Land East of  
**Park View**  
Woodstock

Environmental Statement Addendum

- 1.1 In June 2025, Blenheim Estate Homes submitted an outline planning application to Cherwell District Council (CDC) for the construction of up to 500 dwellings and commercial floorspace (use class E) with associated access, open space and infrastructure at Land East of Park View, Woodstock (application reference: 25/01510/OUT). The application was accompanied by an environmental statement (ES).

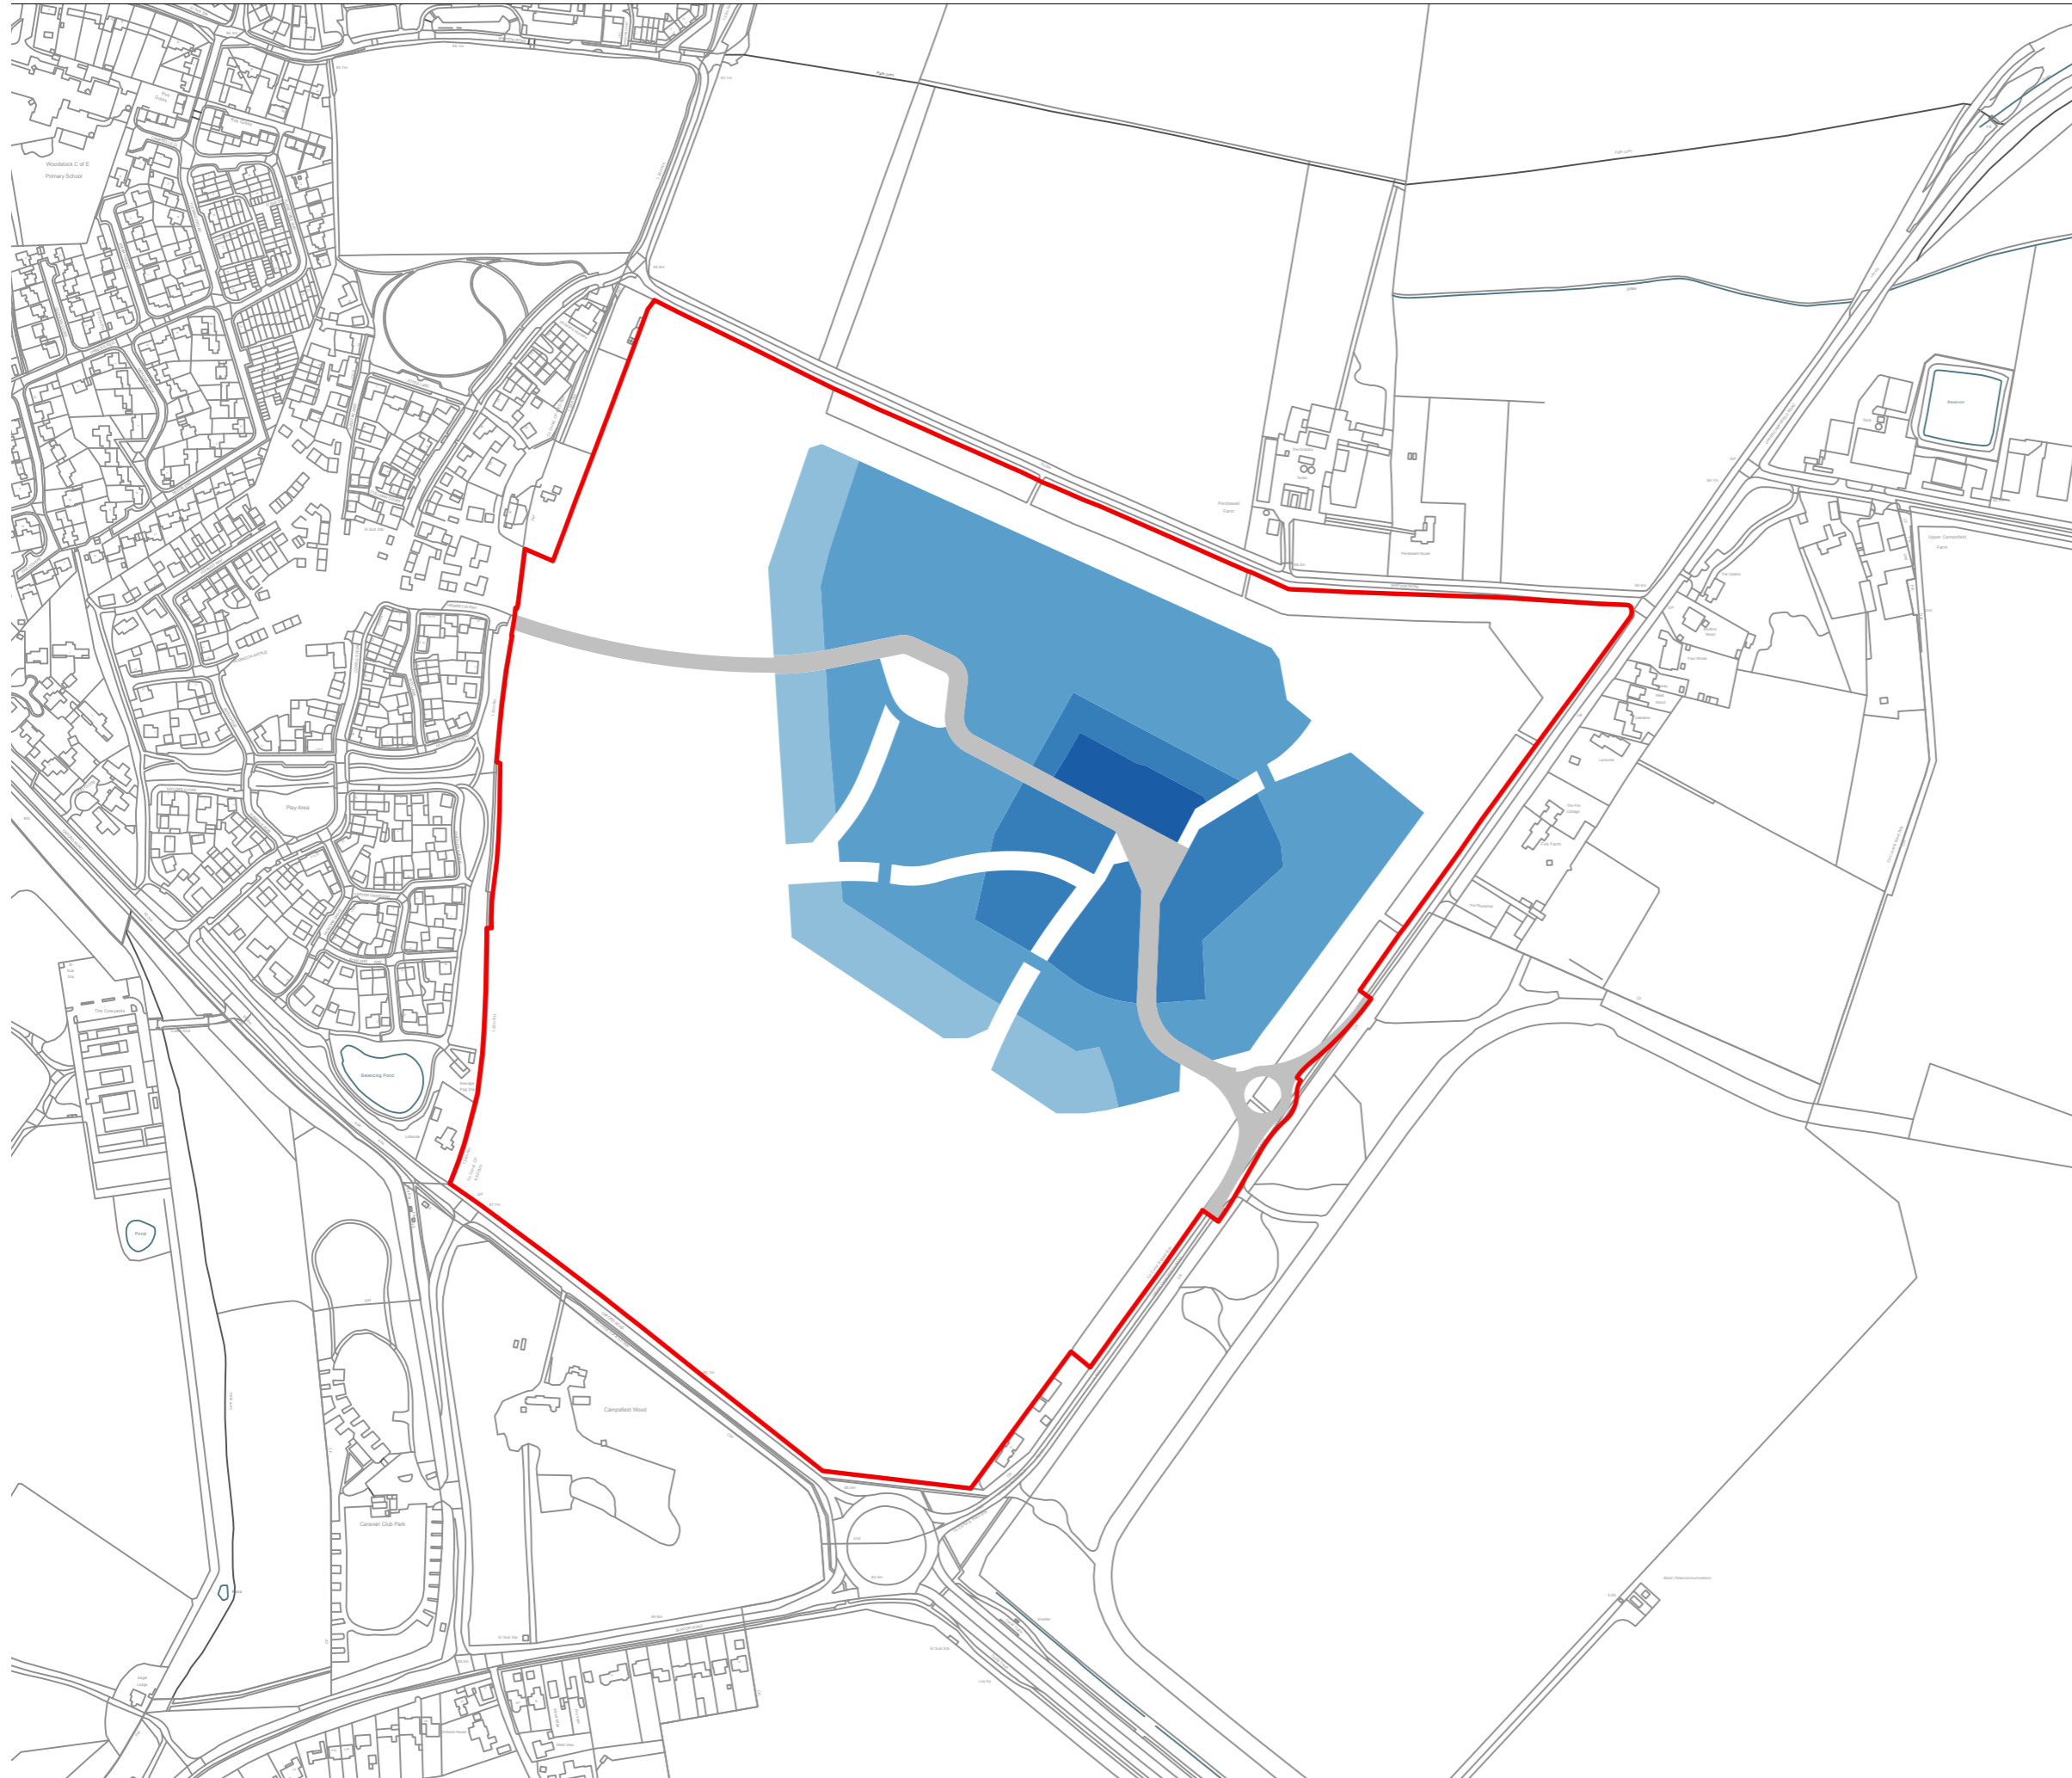
- 2.12 Figures NTS.3a to NTS.3e (parameter plans) and NTS.4 are deleted and replaced with the revised versions included at the end of this section.

- 2.16 Figures 2.2a to 2.2e (parameter plans) are deleted and replaced with the revised versions included at the end of this section.

- Figure NTS.3e / 2.2e: Access and movement parameter plan
- Figure NTS.4 / 3.2: Location of developments considered in the cumulative effects assessment

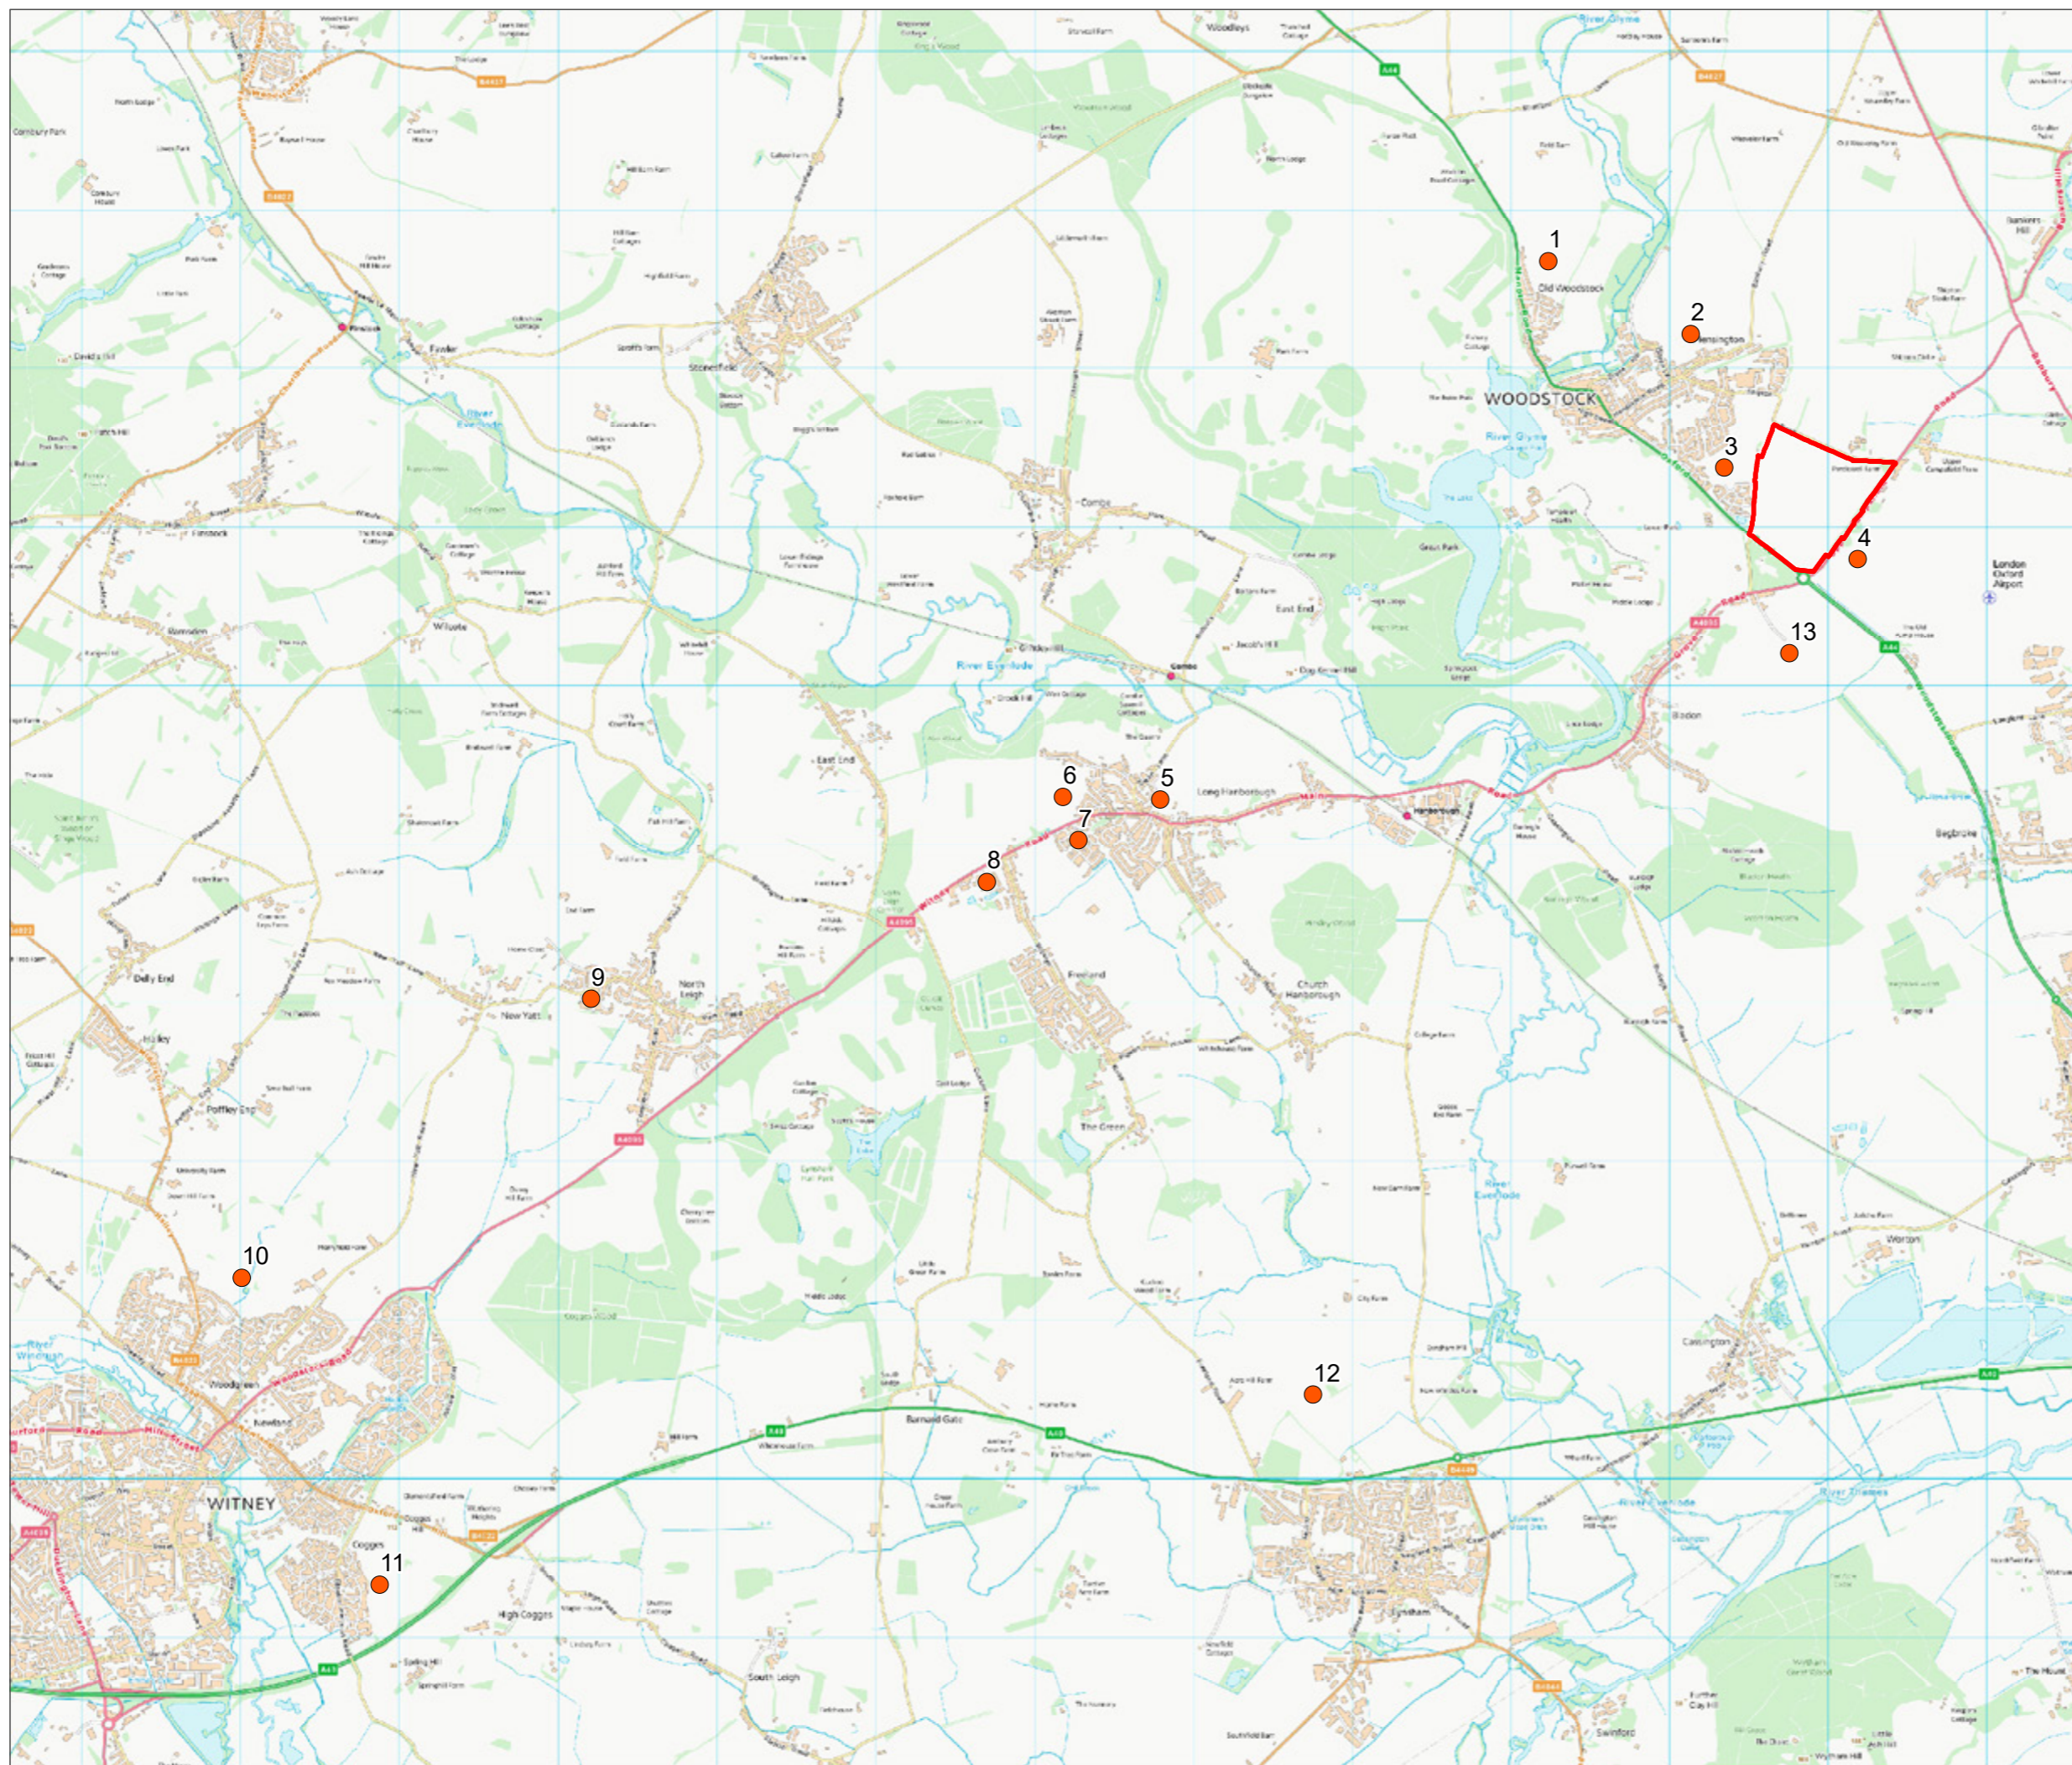
- 2.18 Figure 3.2 is deleted and replaced with the revised version included at the end of this section.
